SERVICE BULLETIN

BULLETIN NUMBER: **175**

MODEL: Diesel Generators WMD, BCD, BTD up to 12.5 KW and BTDA up to 12.5 KW

SUBJECT: Fuel Solenoid #023041 Circuit Improvement

Illustration of Circuit Breaker and Red Wire Lead
Between the
Preheat Solenoid and Fuel Solenoid

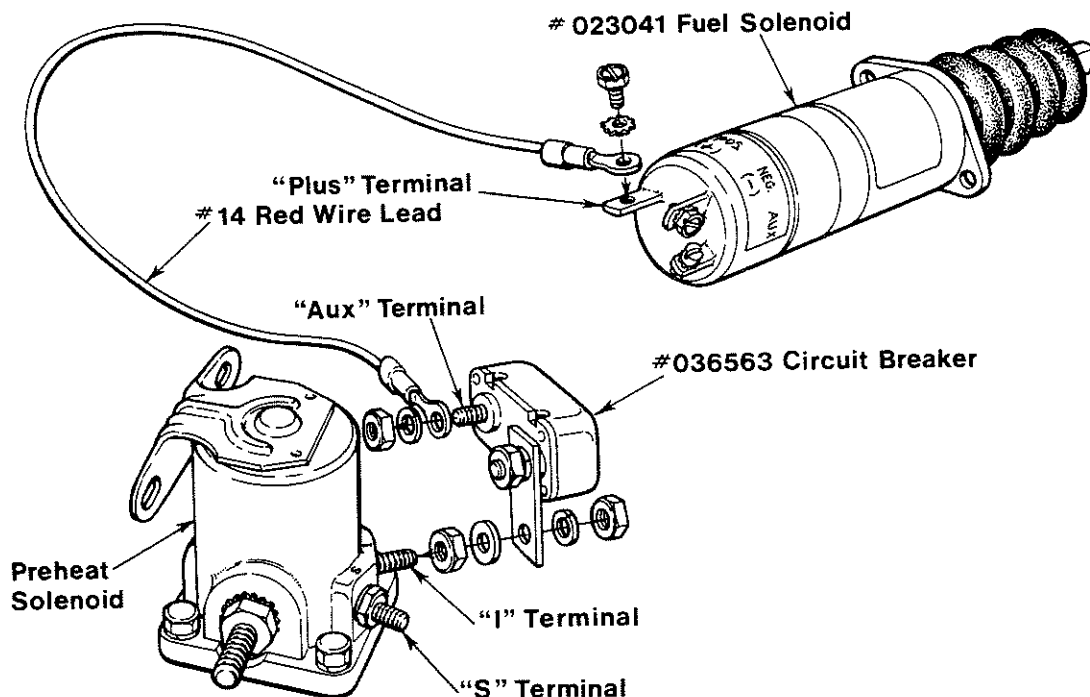
In an effort to prevent fuel solenoid failures that are the result of a voltage loss/reduction in the fuel solenoid circuit during "preheat" and "start," this circuit is now energized using battery voltage available at the "I" terminal on the preheat solenoid when this solenoid is energized during "preheat."

Early model WMD, BCD, BTD and BTDA units up to 12.5 KW can incorporate this circuit by installing circuit breaker assembly #036563 to the vacant "I" terminal of the unit's preheat solenoid and running a #14 red wire from the "aux" terminal of the circuit breaker assembly over to and connecting with the leads presently attached to the "plus" terminal of the fuel solenoid #023041. Ensure this wire is secured and protected against chafing and engine hot areas it passes near.

NOTE: The "I" terminal 10 - 32 threads, circuit breaker connection #10 terminal end for #14 wire, fuel solenoid (plus) terminal #8 terminal end for #14 wire, and #14 wire - length as required.

WIRING DIAGRAM

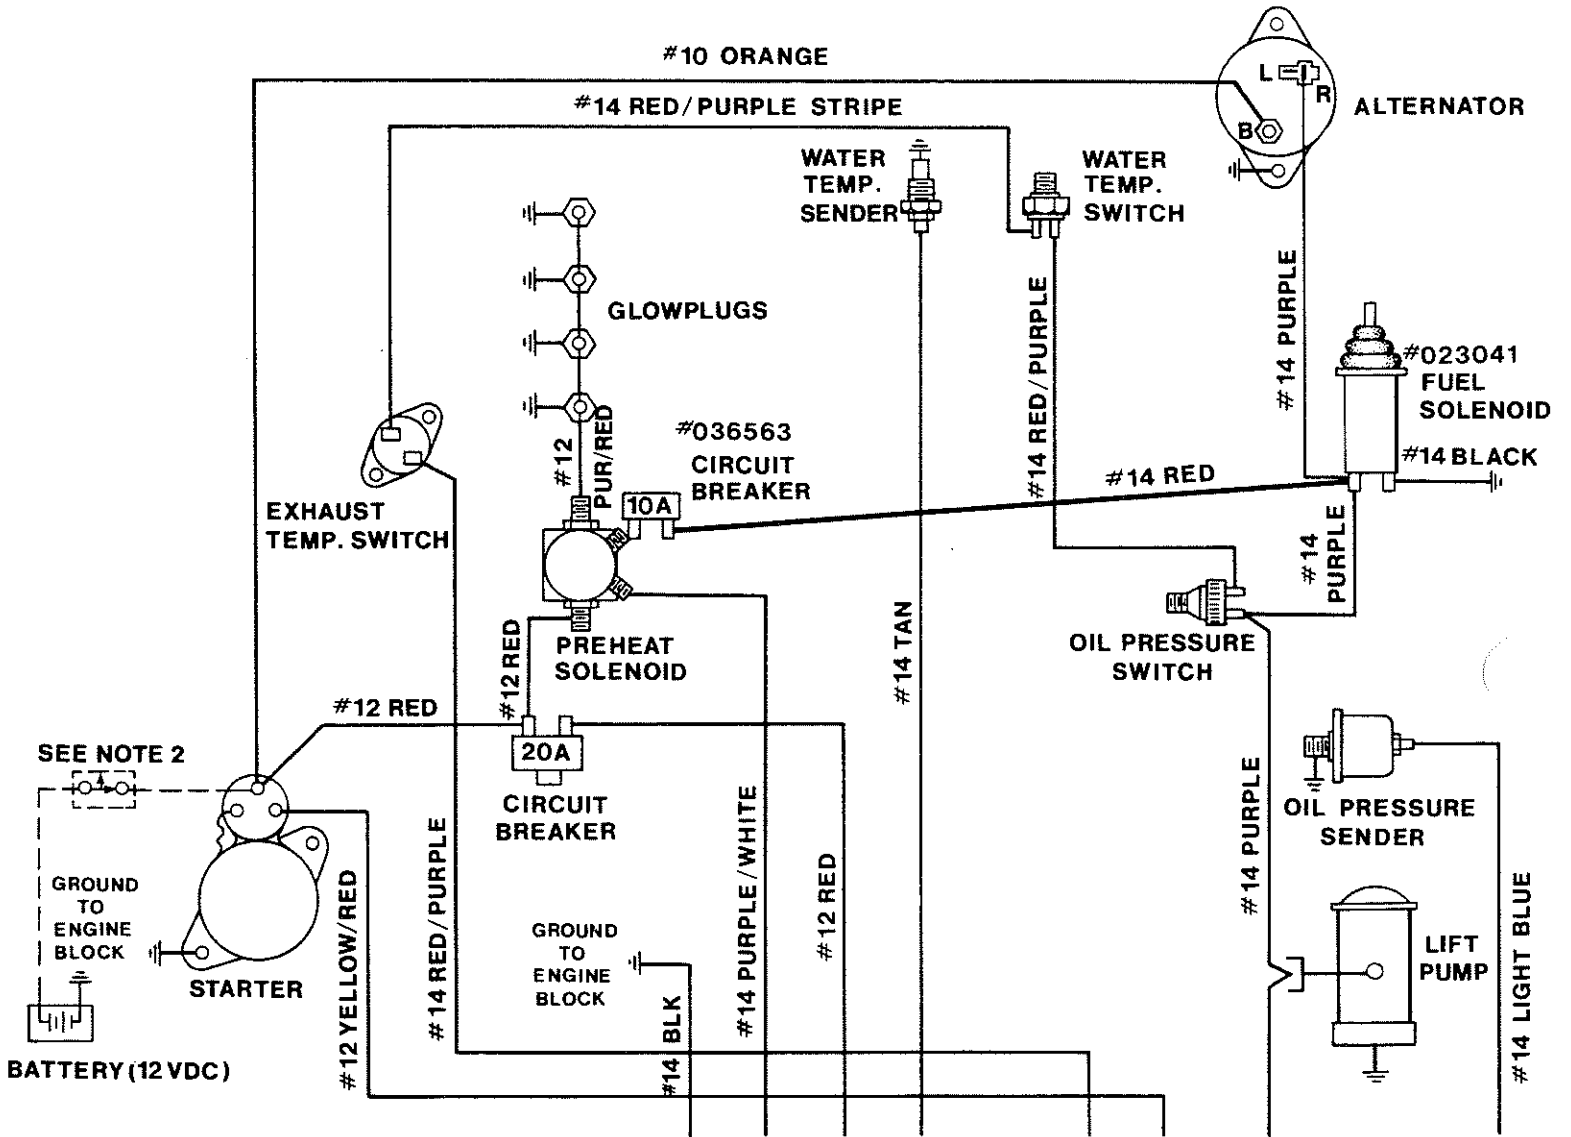
The wiring diagram, on the reverse of this page shows this circuitry being installed on earlier model diesel generators as listed above.
